Preservation Department – Item 1, LPC-22-08731

**6301 12th Avenue, aka 6301-6323 12th Avenue, 1202-1216 63rd
Street, and 1201-1215 64th Street – Angel Guardian Home –
Individual Landmark
Borough of Brooklyn**

LPC-22-08731: 6301 12th Avenue, Angel Guardian Home - Individual Landmark

PUBLIC MEETING SCOPE 09/20/2022

REAR FACADE
REVISED RENDERING

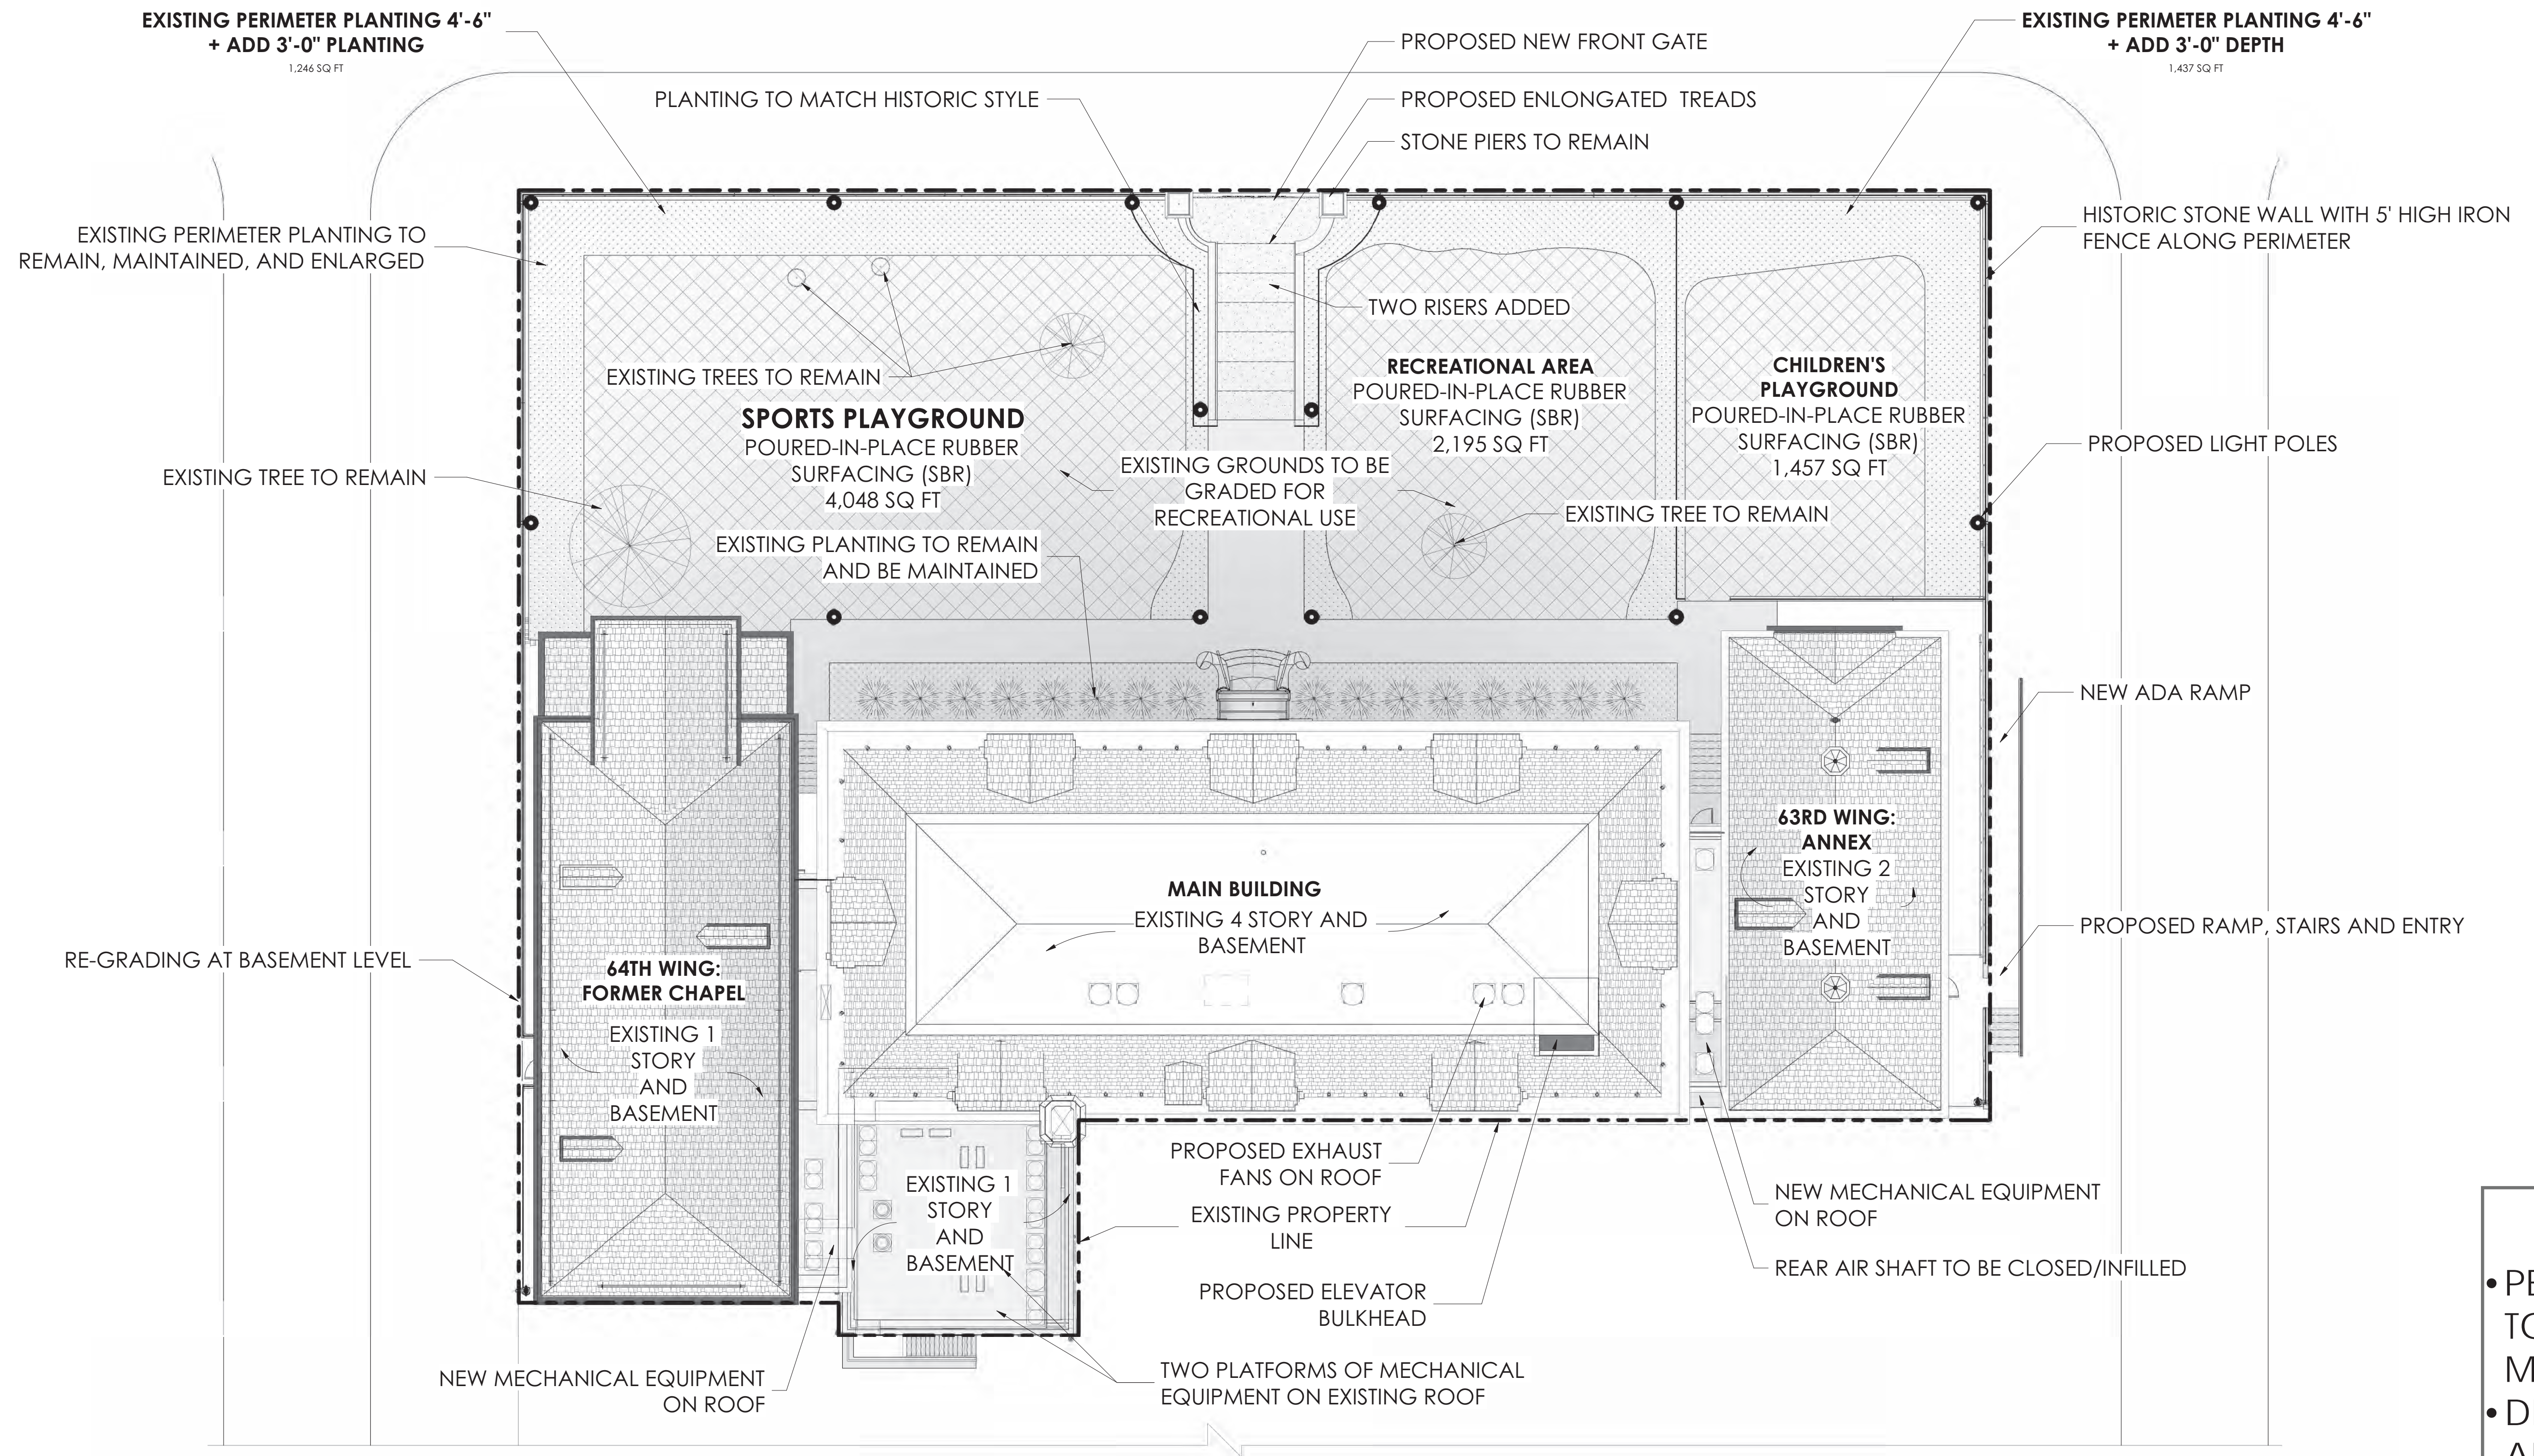
- ELEVATOR BULKHEAD HEIGHT
- DOWNSPOUTS MATCH COPPER
- ADDITIONAL REAR FACADE LIGHT AND SECURITY CAMERA FIXTURES
- NEW MECHANICAL LOUVRE
- MECHANICAL DUNNAGE WIDENED

PROPOSED DESIGNS:

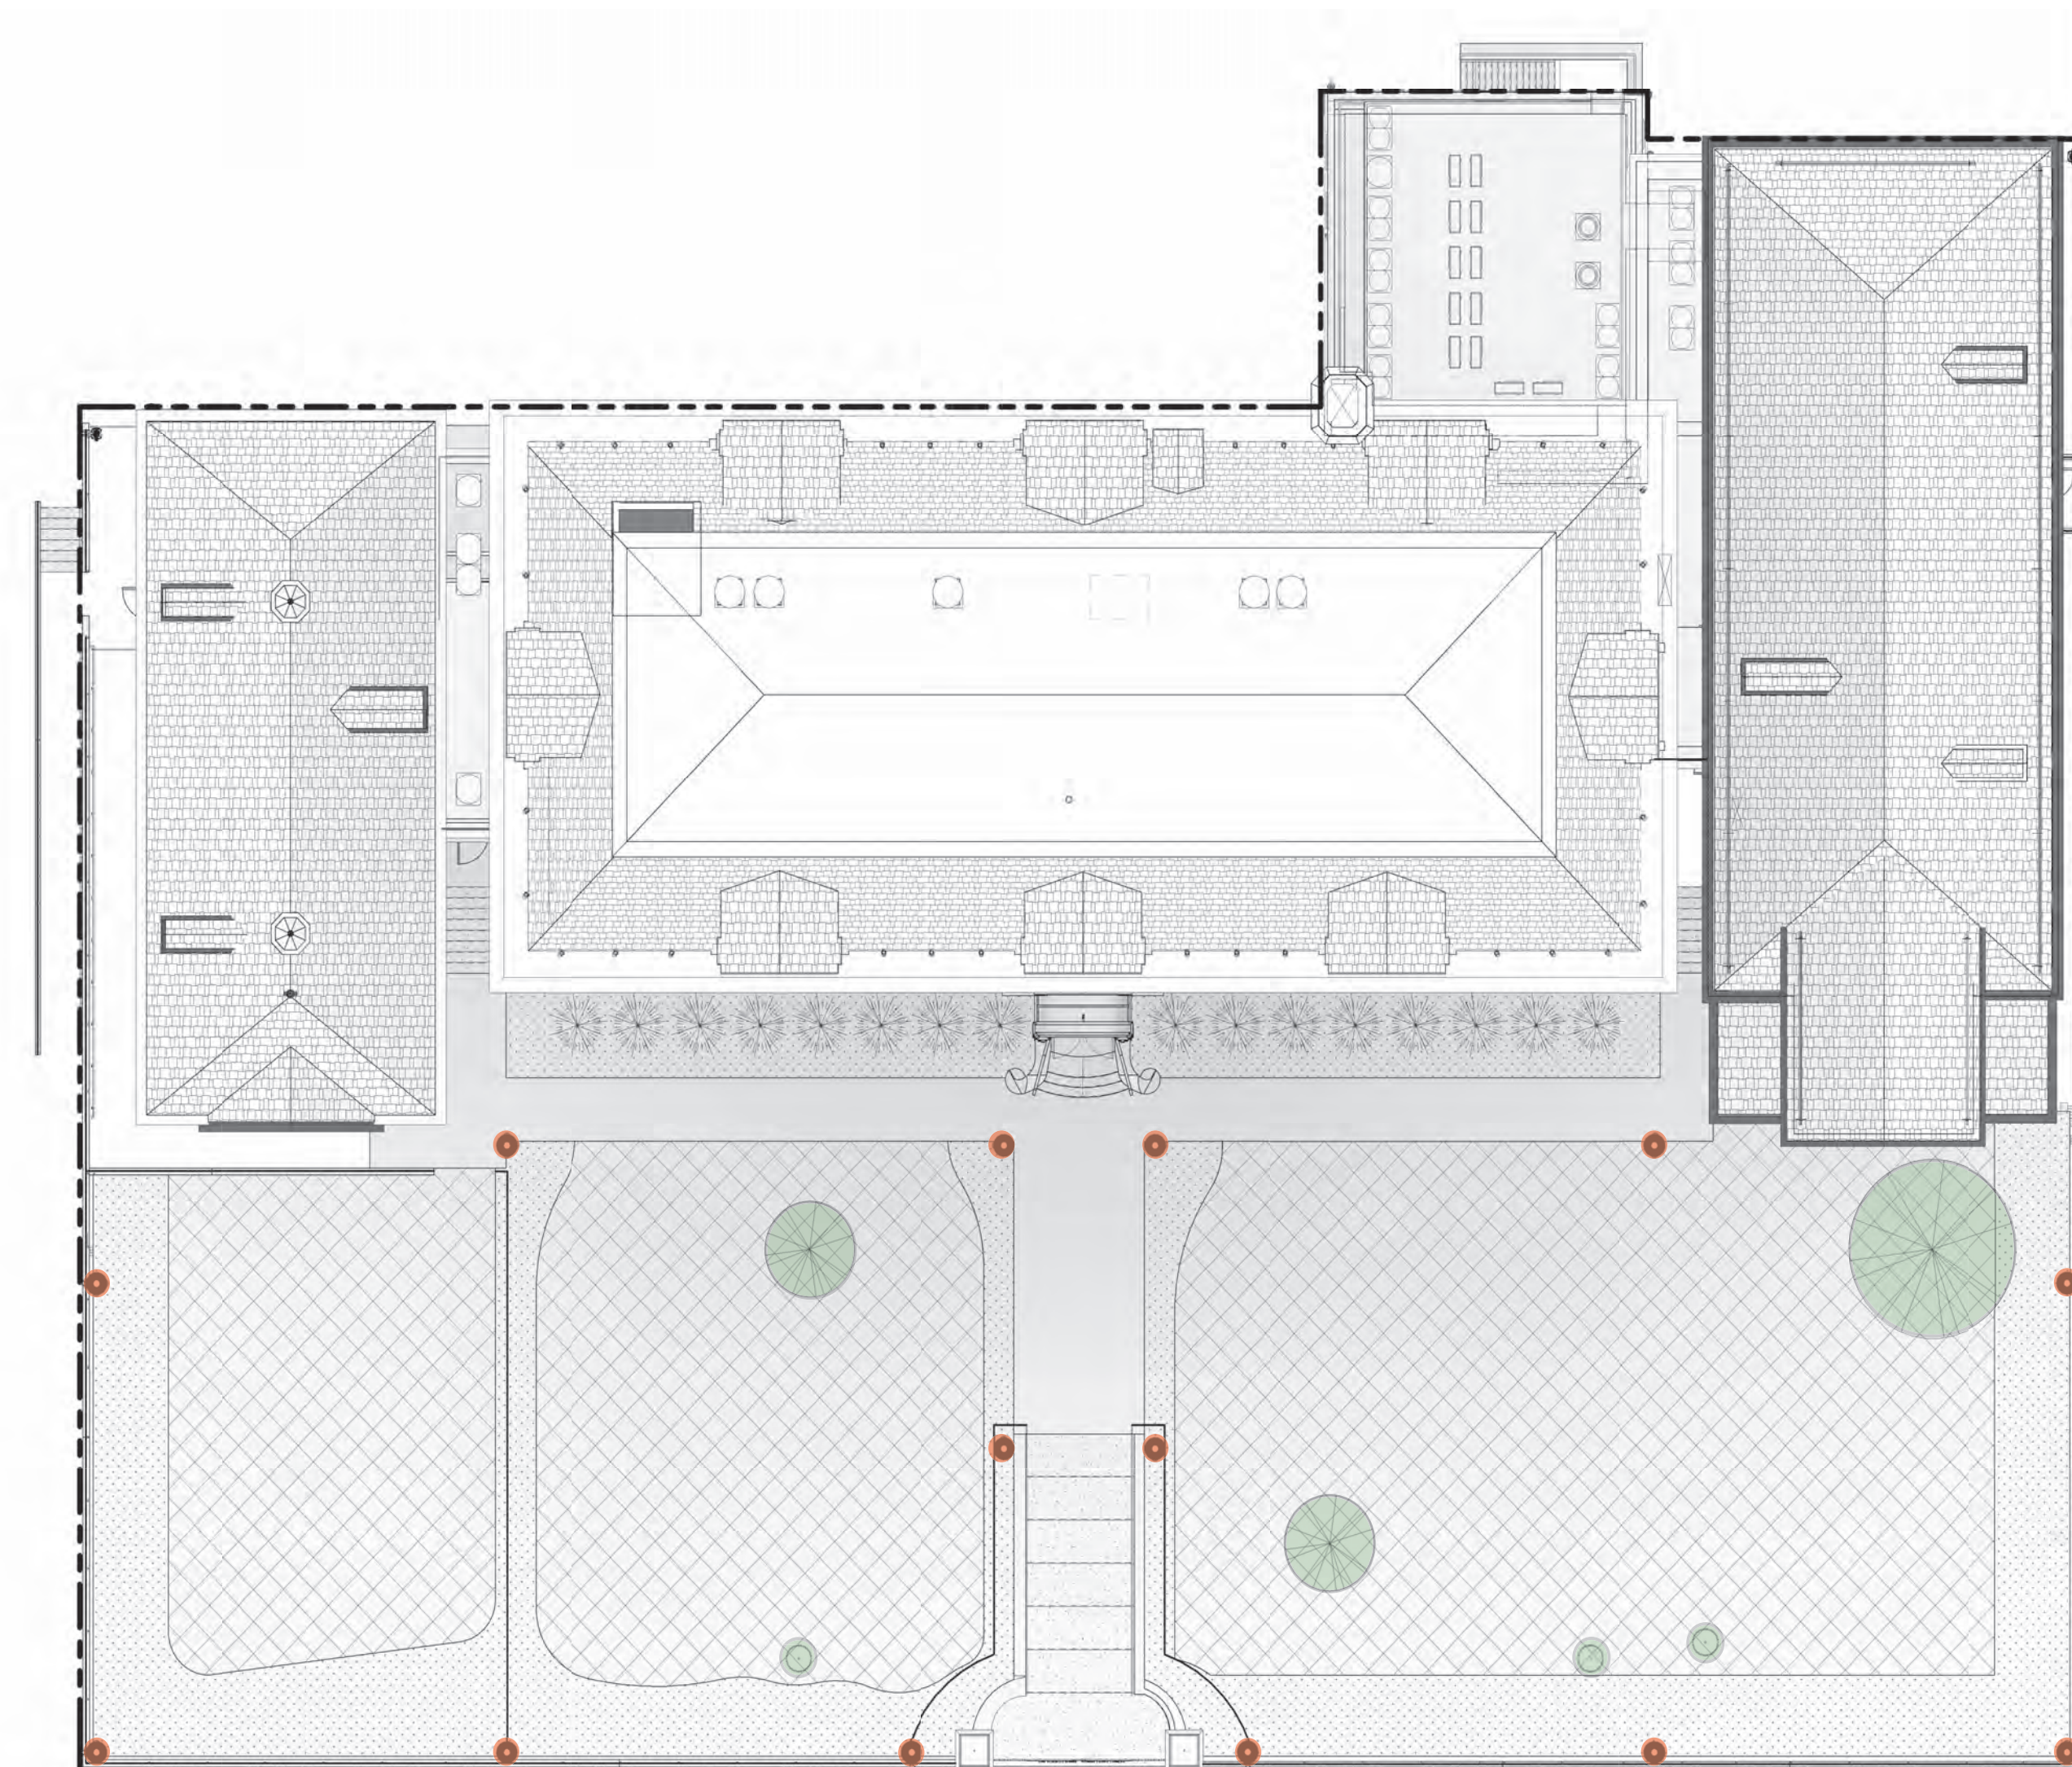
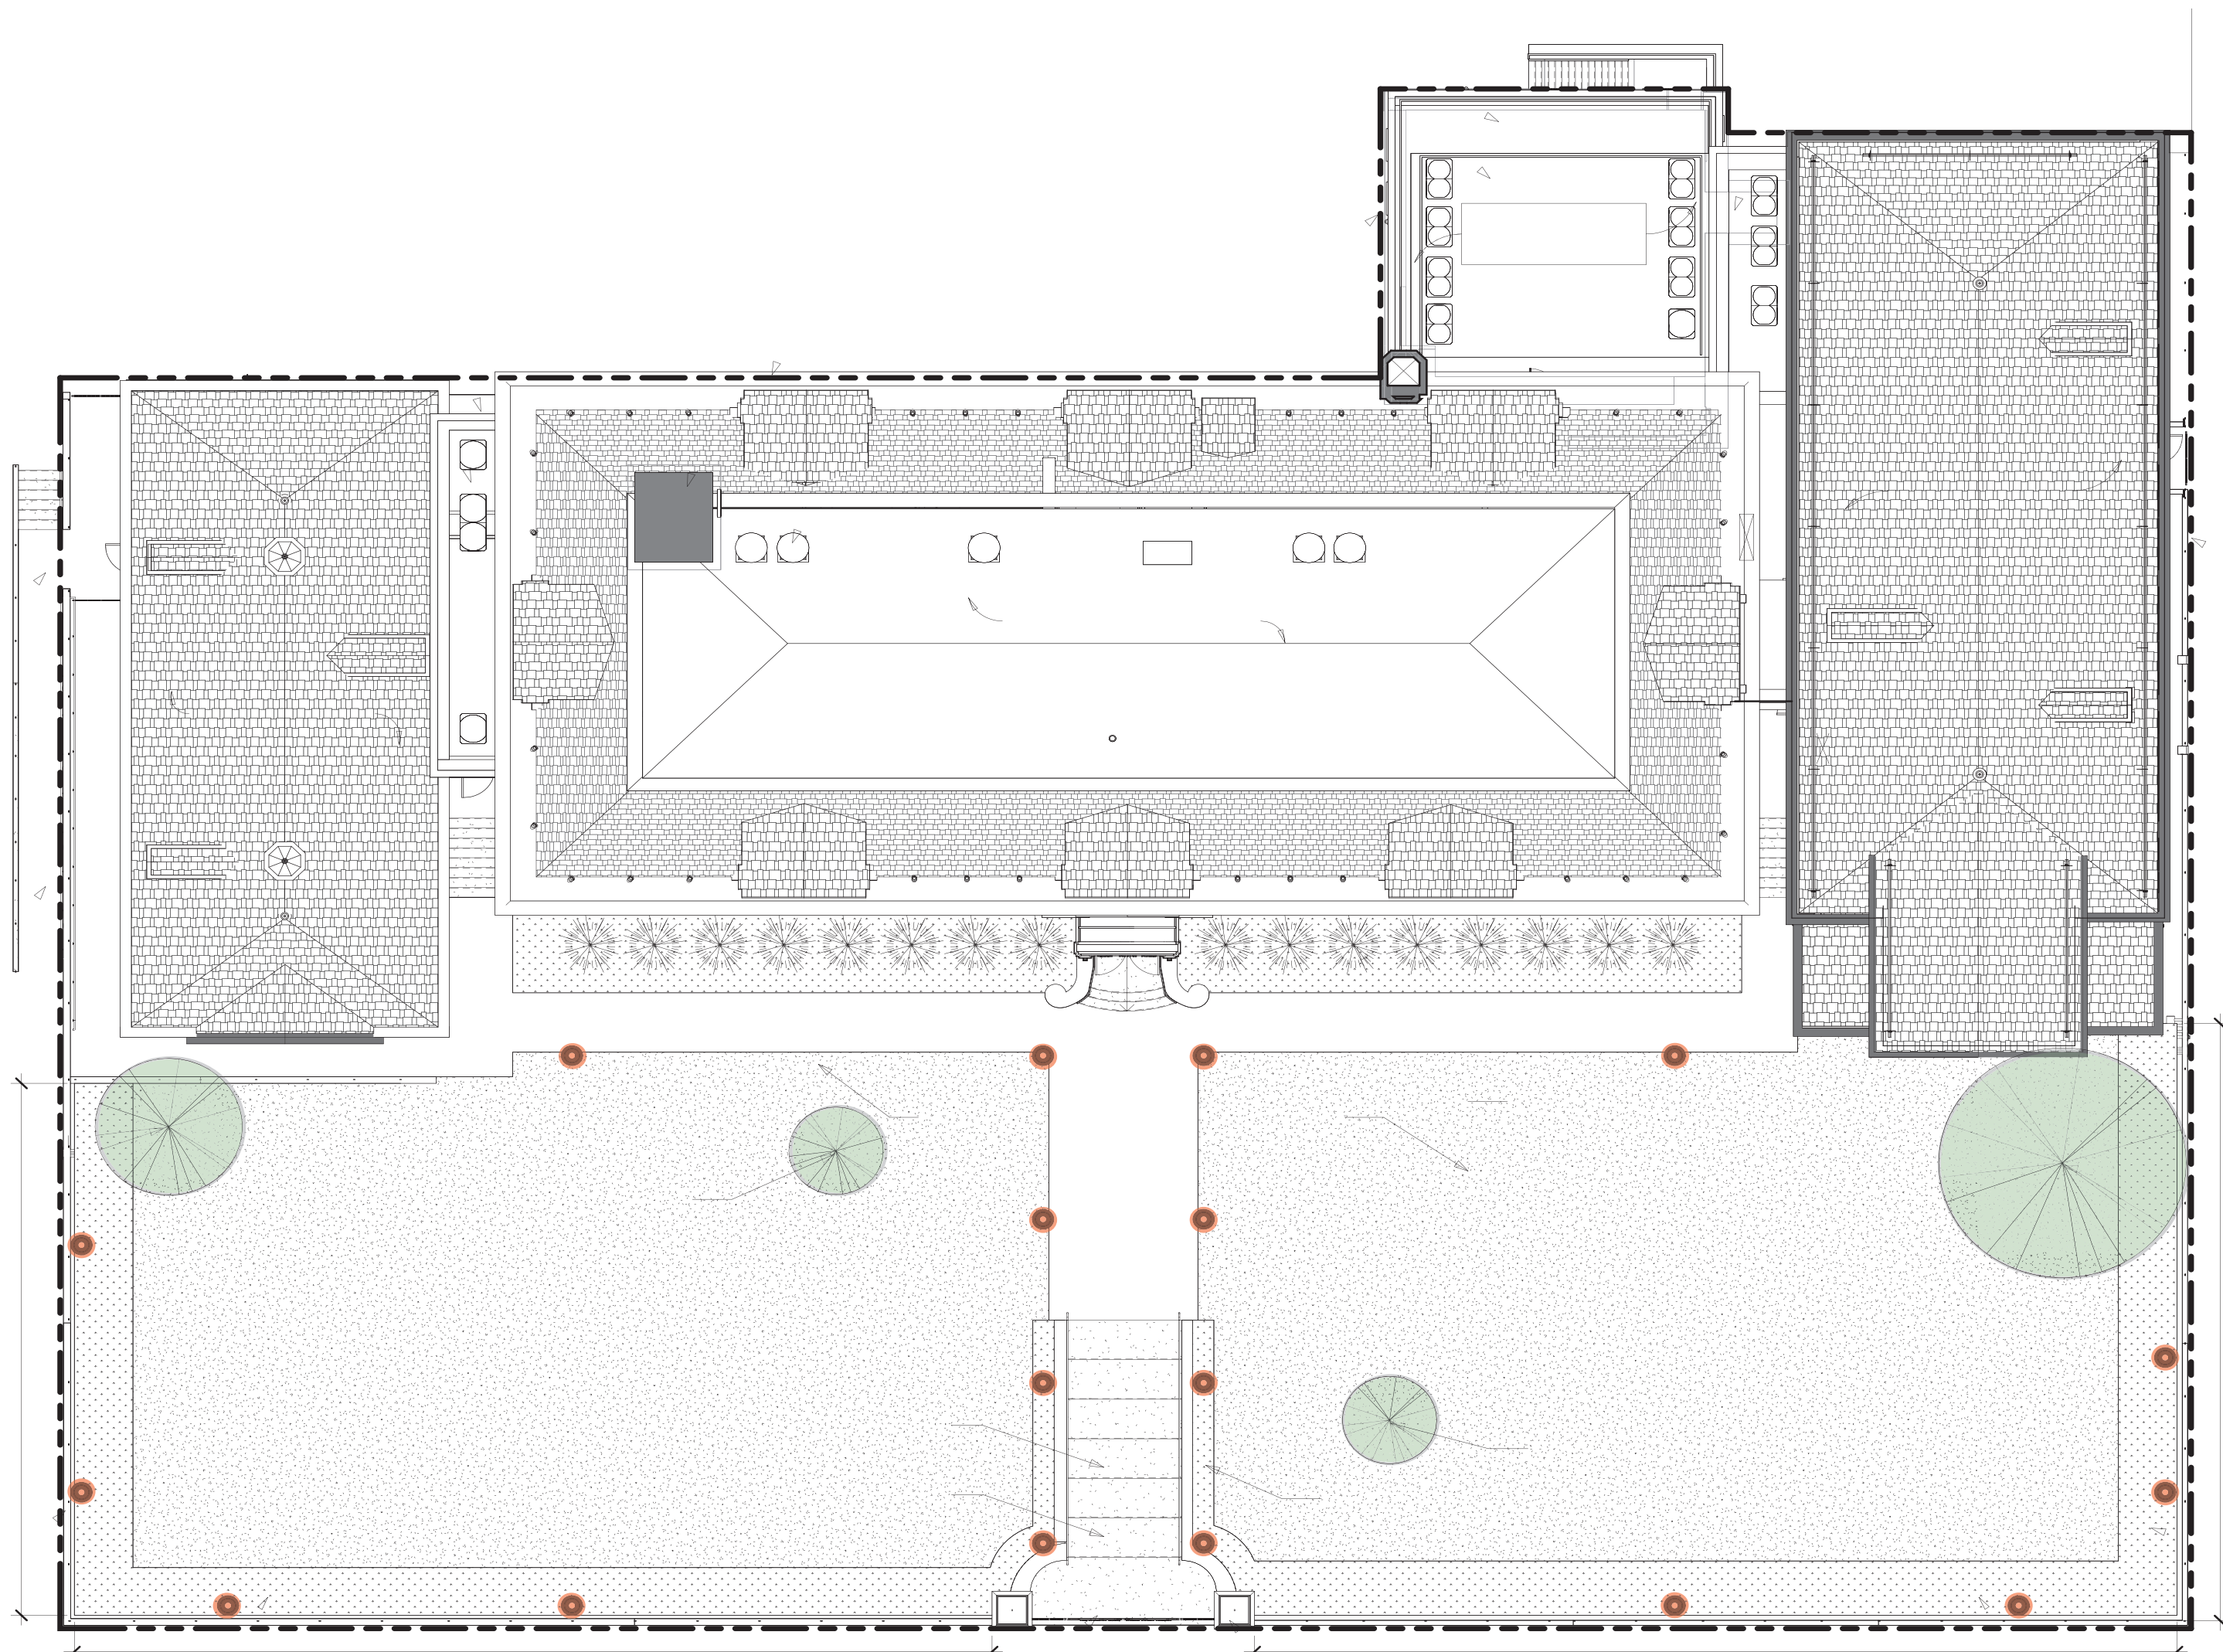
- PERIMETER PLANTING TO BE WIDENED AND MAINTAINED
- DEVELOPED PLAY AREAS AND DIVIDED UP THE POURED RUBBER PLAY SPACES
- PLACED GRASS BORDER THROUGHOUT THE PLAY SPACES
- REVISED LIGHT POLE PLACEMENT
- TREE IN FRONT OF 63RD ST WING TO BE REMOVED
- ADDITIONAL TREES TO REMAIN
